City of Portland, Maine – Building or Use Permit Application 389 Congress Street, 04101, Tel: (207) 874-8703, FAX: 874-8716

BUILDING PERMIT REPORT

REASON FOR PERMIT: To Construct deck by pool

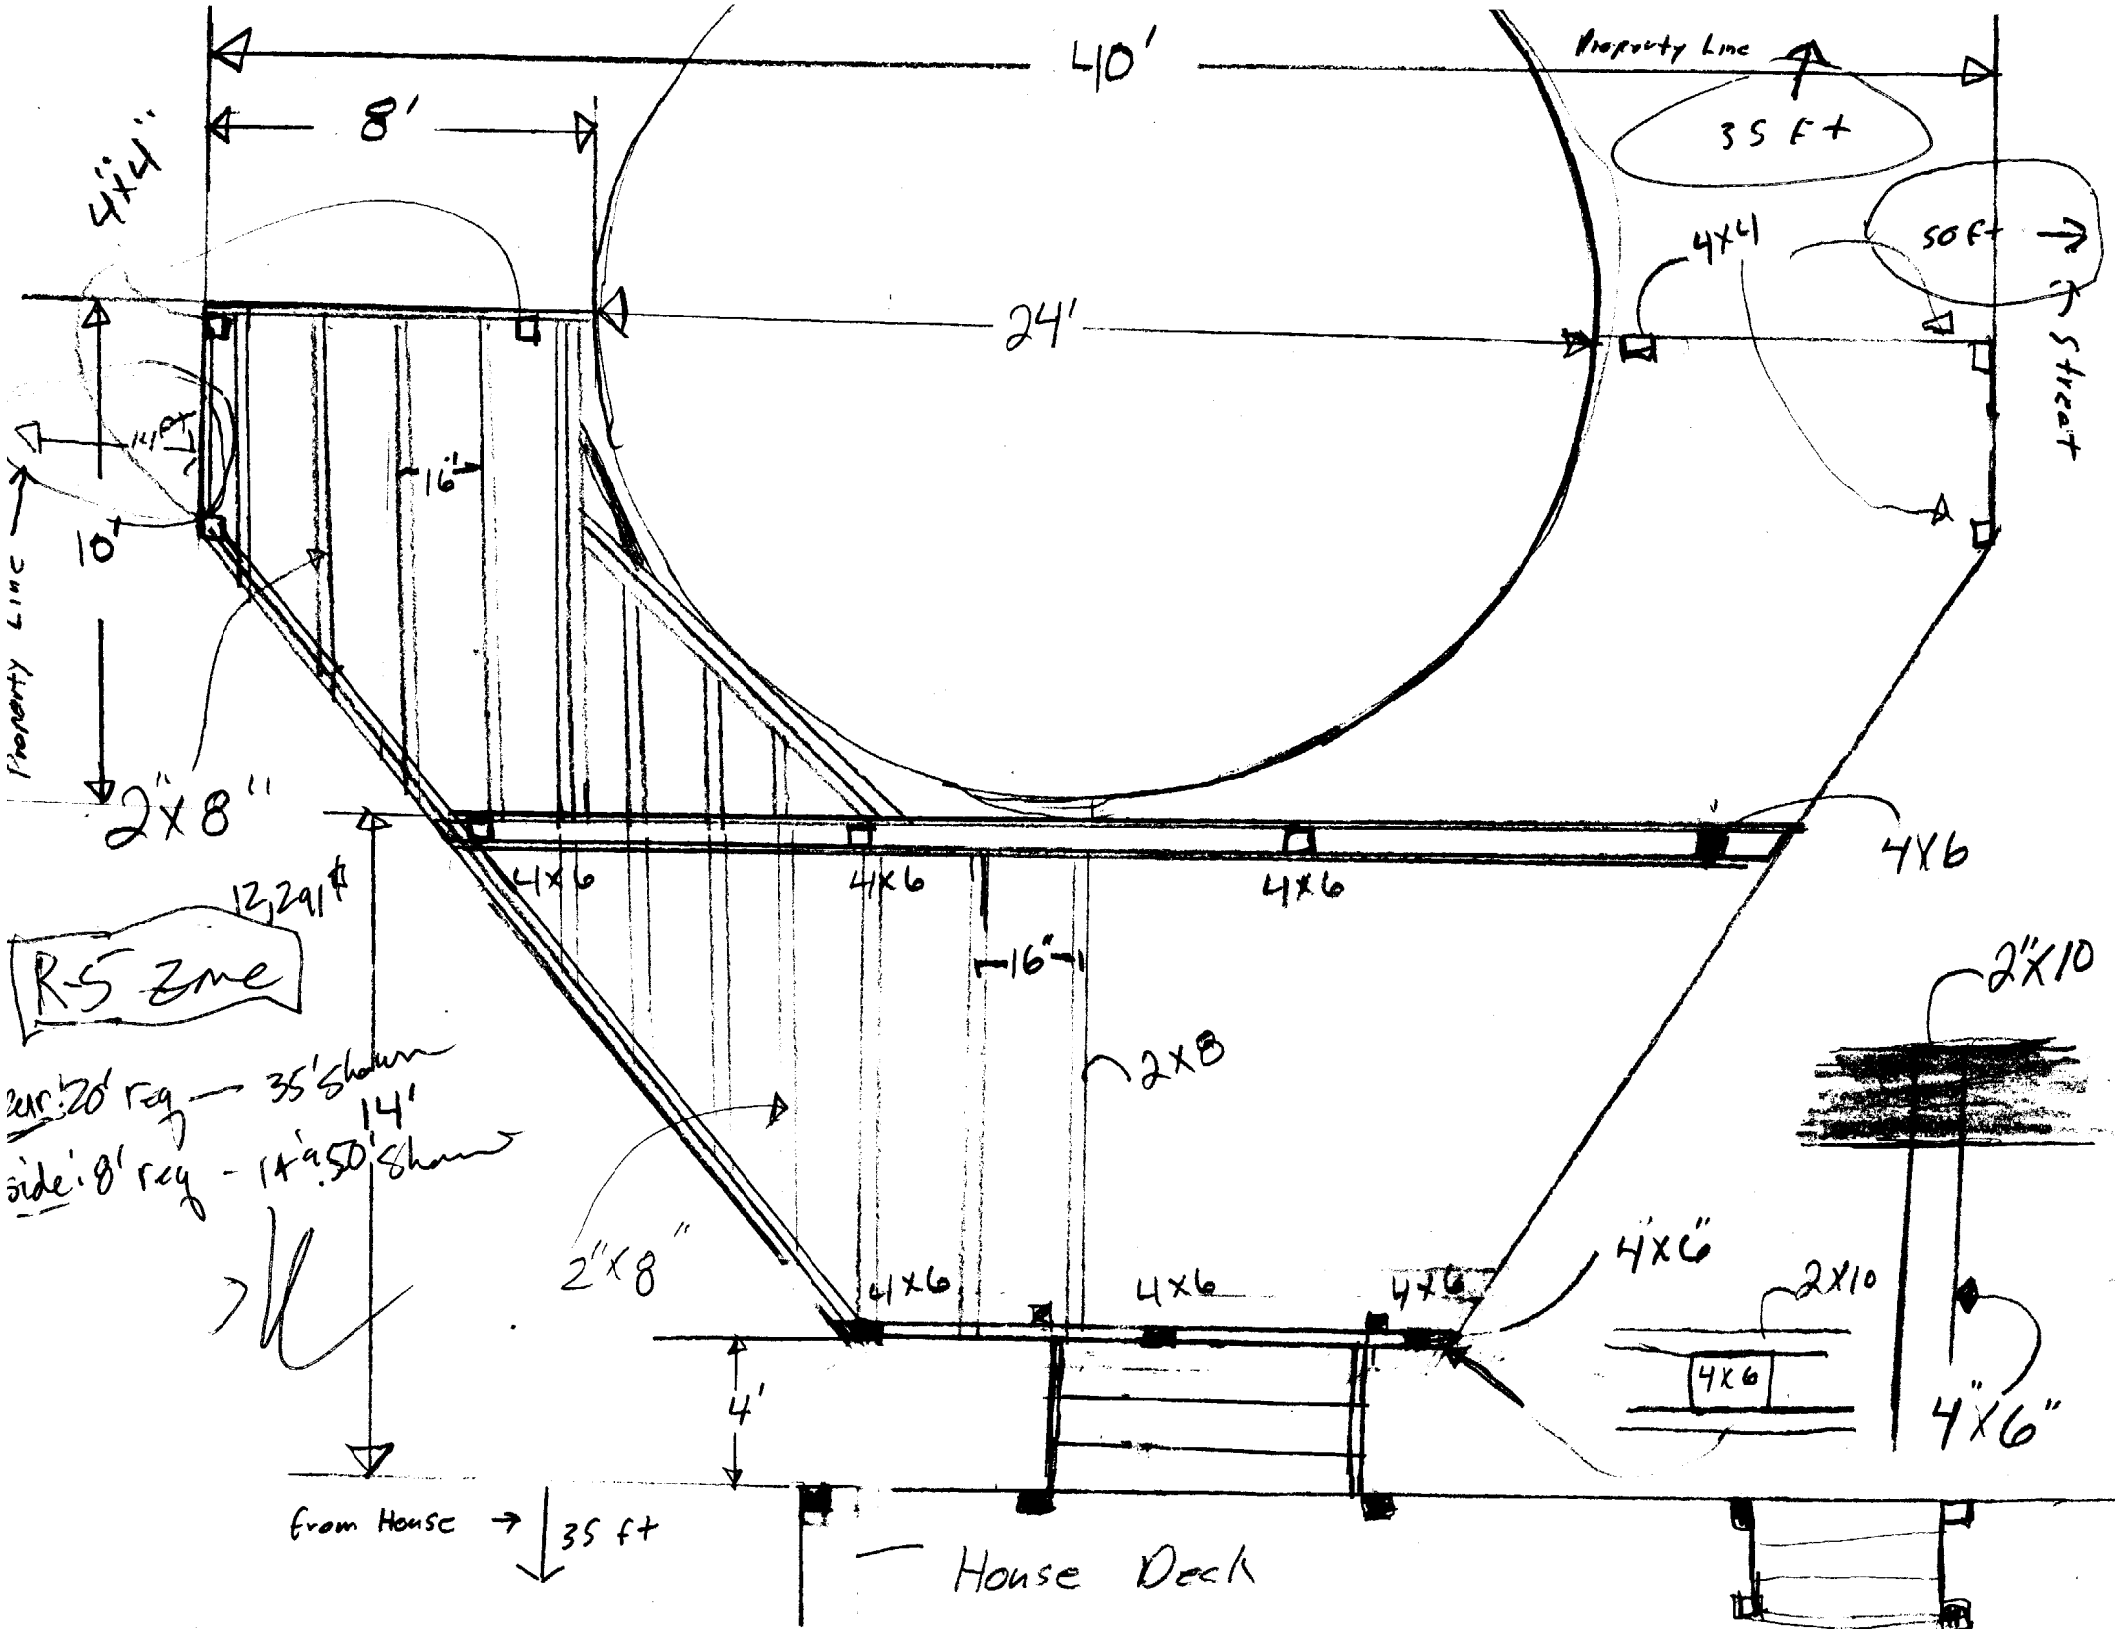
24' x 20' req - 35' shown
 side: 8' req - 14' x 50' shown
